June 22, 2005
RC-05-0090

Subject: VIRGIL C. SUMMER NUCLEAR STATION
DOCKET NO. 50/395
OPERATING LICENSE NO. NPF-12
LICENSE AMENDMENT REQUEST
REACTOR COOLANT SYSTEM – HEATUP/COOLDOWN CURVES

**LICENSE AMENDMENT REQUEST
TECHNICAL SPECIFICATION 3/4.4.9 AND ASSOCIATED BASES**

Unit 1
 Figure 3.4-2 V. C. Summer Reactor Coolant System Heatsup Limitations (Heatup Rates of 50 and 100°F/hr) Applicable for 56 EFPY (Without Margins for Instrumentation Errors) Using 1998 Appendix G Methodology

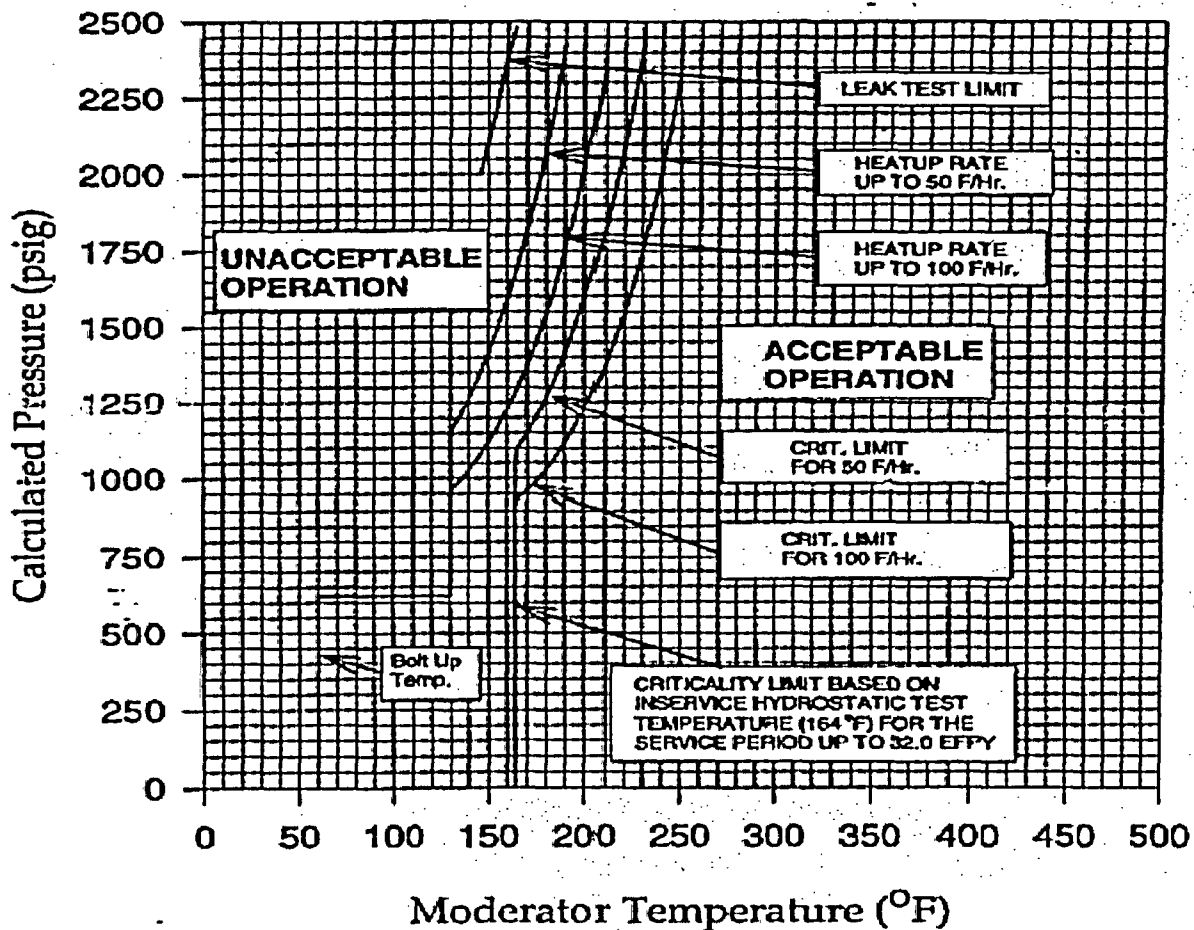
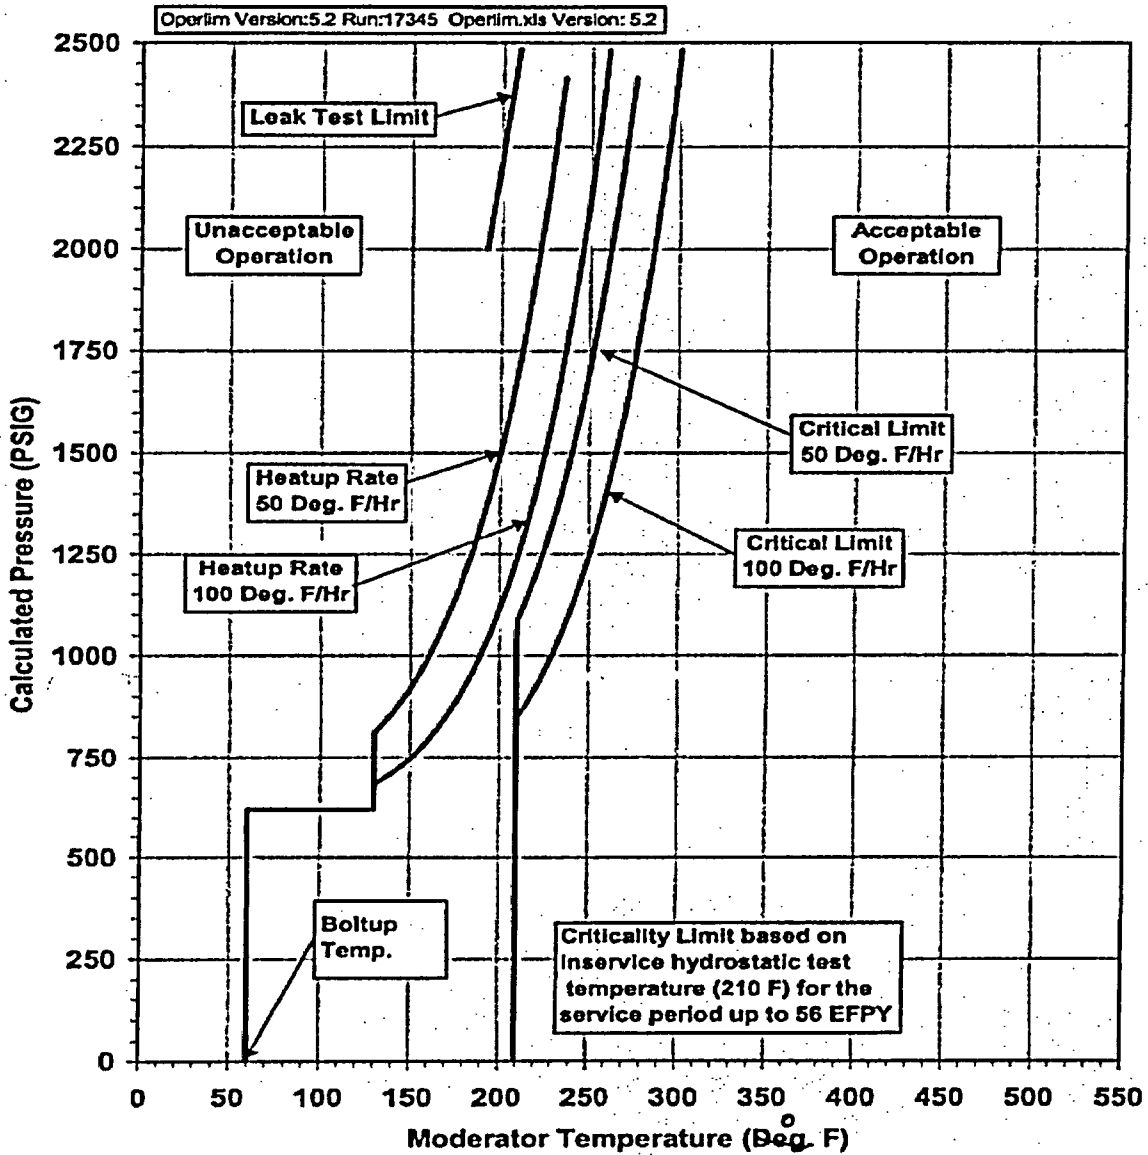
These figures provide the VCSNS Reactor Coolant System heatup and cooldown limitations. The proposed changes incorporate the latest available reactor vessel information and updated calculated fluences, and also extend the applicability of the figures up to 56 EFPY. These proposed curves are more limiting than those currently contained in the TS.

<u>Page</u>	<u>Affected Section</u>	<u>Description of Change</u>	<u>Reason for Change</u>
3/4 4-31	Figure 3.4-2	Replace heatup curve	Revised P/T limits based on analysis of reactor vessel surveillance capsule.
3/4 4-32	Figure 3.4-3	Replace cooldown curve	Revised P/T limits based on analysis of reactor vessel surveillance capsule.
B3/4 4-6	B3/4.4.9	Added updated design basis information.	Revised ASME Code reference.
B3/4 4-14	B3/4.4.9	Deleted unnecessary information contained with in Bases section and updated applicable Bases information.	Correct reference for P/T limit curves.

Replace with
new Figure 3.4-2

MATERIAL PROPERTY BASIS: Limiting Material: Intermediate Shell Plate A9154-1
 Limiting ART Values @ 56 EFPY: 1/4T: 153°F, 3/4T: 138°F

Figure 3.4-3V. C. Summer Reactor Coolant System Cooldown Limitations (Cooldown Rates up to 100°F/hr) Applicable for 56 EFPY (Without Margins for Instrumentation Errors) Using 1998 Appendix G Methodology

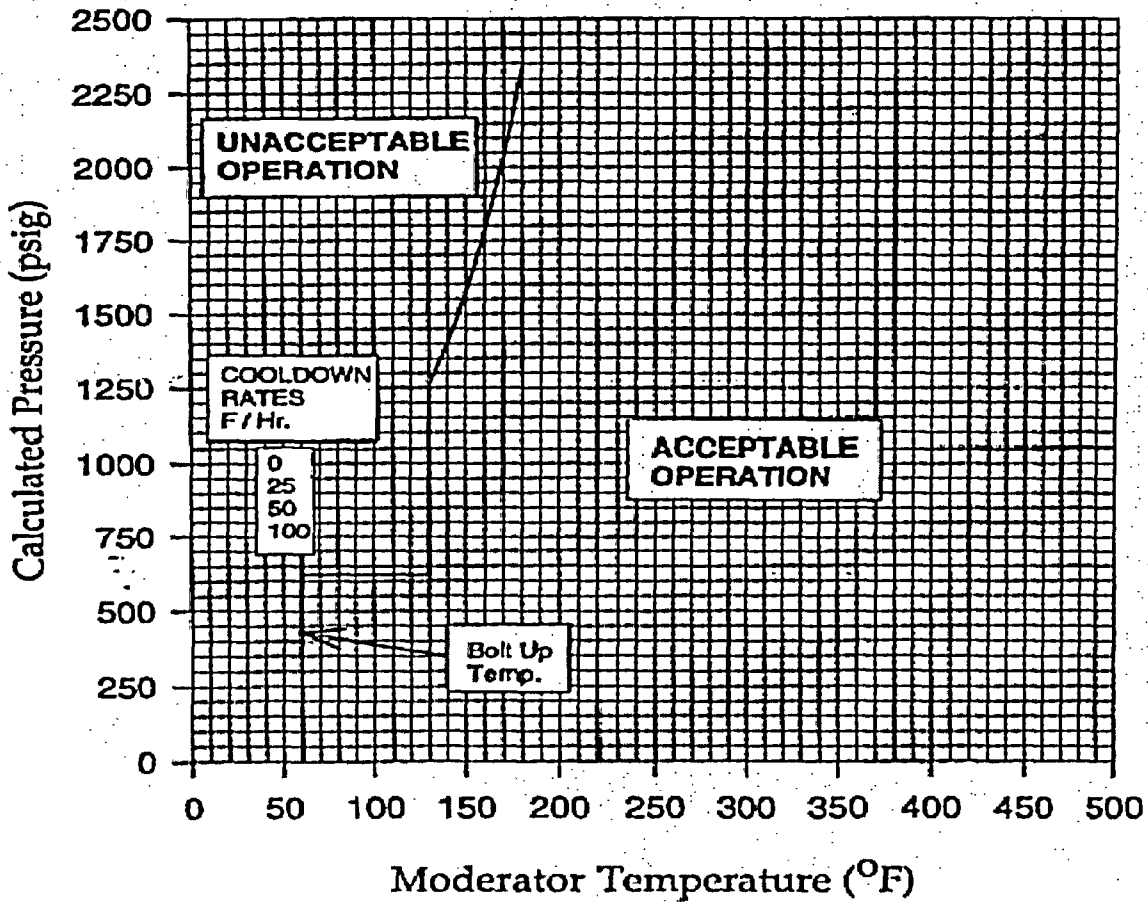
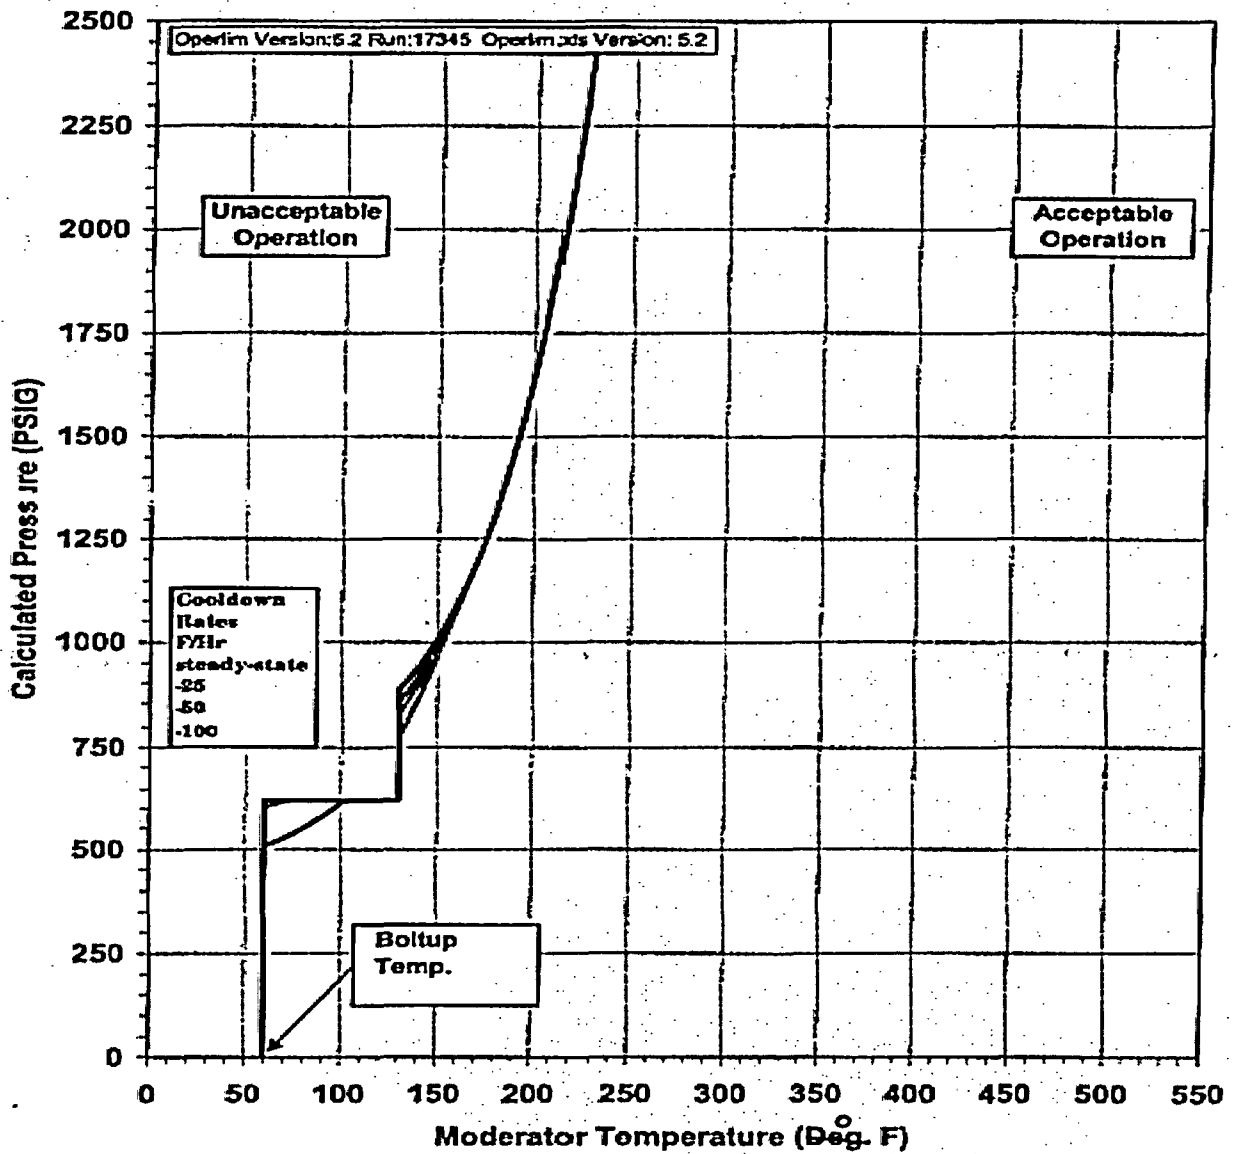
Replace with new
 Figure 3.4-3

MATERIAL PROPERTY BASIS: Limiting Material: Intermediate Shell Plate A9154-1
 Limiting ART Values @ 56 EFPY: 1/4T: 153°F, 3/4T: 138°F
